# HISTORIC AND DESIGN REVIEW COMMISSION

**HDRC CASE NO:** 2018-234  
**ADDRESS:** 1126 E CROCKETT ST  
**LEGAL DESCRIPTION:** NCB 585 BLK 1 LOT 2  
**ZONING:** RM-4 H  
**CITY COUNCIL DIST.:** 2  
**DISTRICT:** Dignowity Hill Historic District  
**APPLICANT:** Michael Perez  
**OWNER:** MP2 Urban Development  
**TYPE OF WORK:** Construction of a 2-story single family structure and a 1-story rear carport  
**APPLICATION RECEIVED:** June 29, 2018  
**60-DAY REVIEW:** August 31, 2018  
**REQUEST:**

The applicant is requesting a Certificate of Appropriateness to construct a 2-story single family home with a 1-story rear carport on the vacant lot located at 1126 E Crockett St.

sheet title:  
Planting Plan  
sheet number:

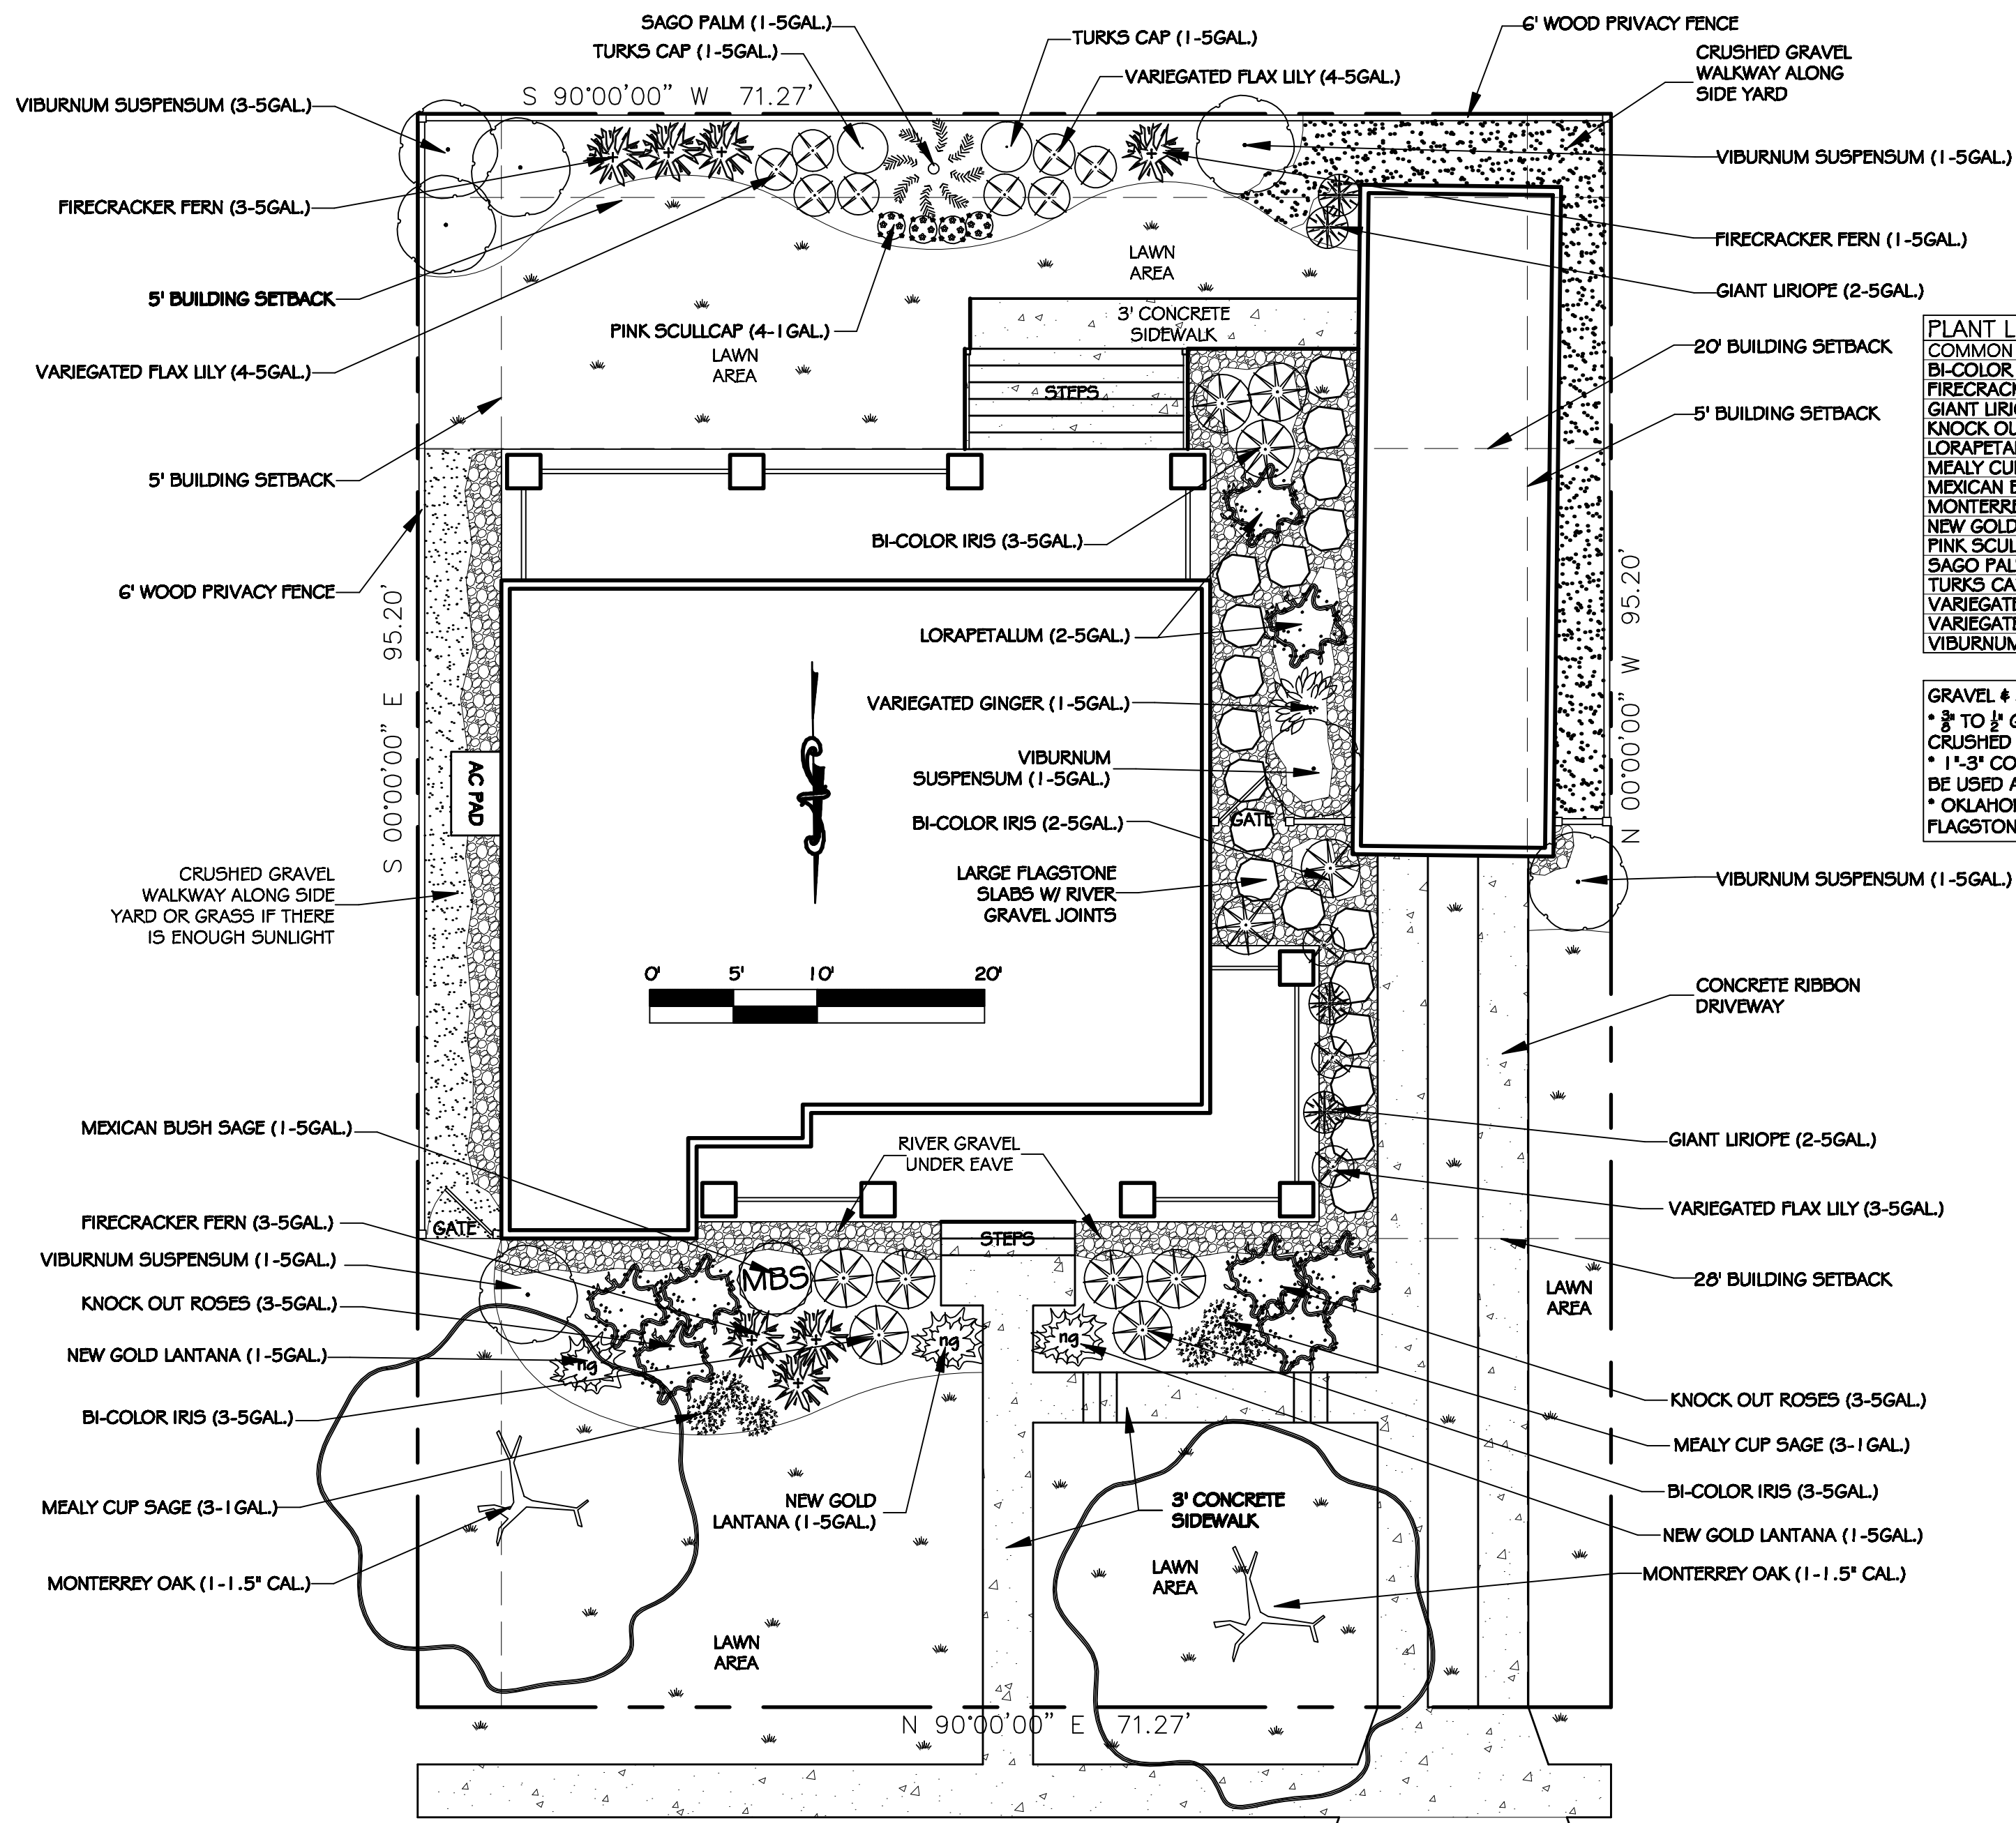
- q. LANDSCAPING – The applicant has proposed to incorporate various new plantings as indicated on the submitted landscaping plan. The plan includes a majority lawn area in the front and back yard with crushed granite and river gravel surrounding the primary structure and the southwestern edge of the carport. The proposal features several new low shrubbery and drought-resistant plantings, along with two new Monterrey Oak trees in the front yard. Staff finds the proposal appropriate.

PREMIUM ATLANTIC ALUMINUM SINGLE-HUNG WINDOW

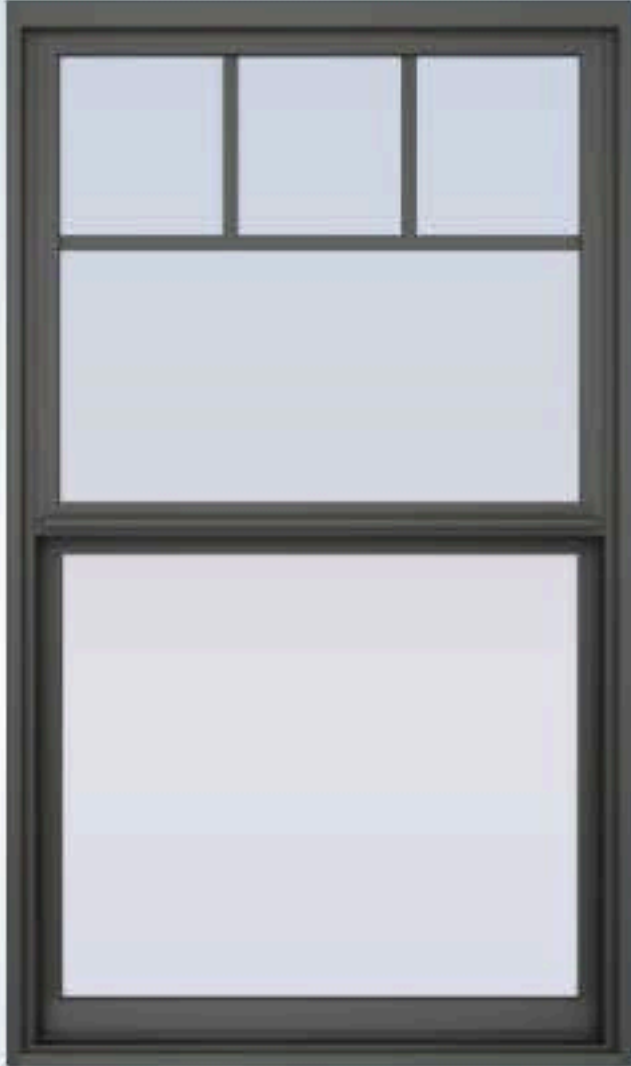
- k. WINDOW & DOOR MATERIALS – The applicant proposed to install aluminum clad wood windows. The windows will be black. The applicant has proposed a product that features a decorative faux divided lite detail on the top sash. While staff finds the color and material of the windows to be appropriate, staff finds that the faux divided lites are inconsistent with the Historic Design Guidelines and the window policy document. Staff recommends that the windows feature a one over one configuration with no divided lites to be consistent.

- ii. That the aluminum-clad wood windows feature a one over one configuration as noted in finding k and meet the following specifications: Meeting rails must be no taller than 1.25" and stiles no wider than 2.25". White manufacturer's color is not allowed, and color selection must be presented to staff. There should be a minimum of two inches in depth between the front face of the window trim and the front face of the top window sash. This must be accomplished by recessing the window sufficiently within the opening or with the installation of additional window trim to add thickness. Window trim must feature traditional dimensions and architecturally appropriate sill detail. Window track components must be painted to match the window trim or concealed by a wood window screen set within the opening.
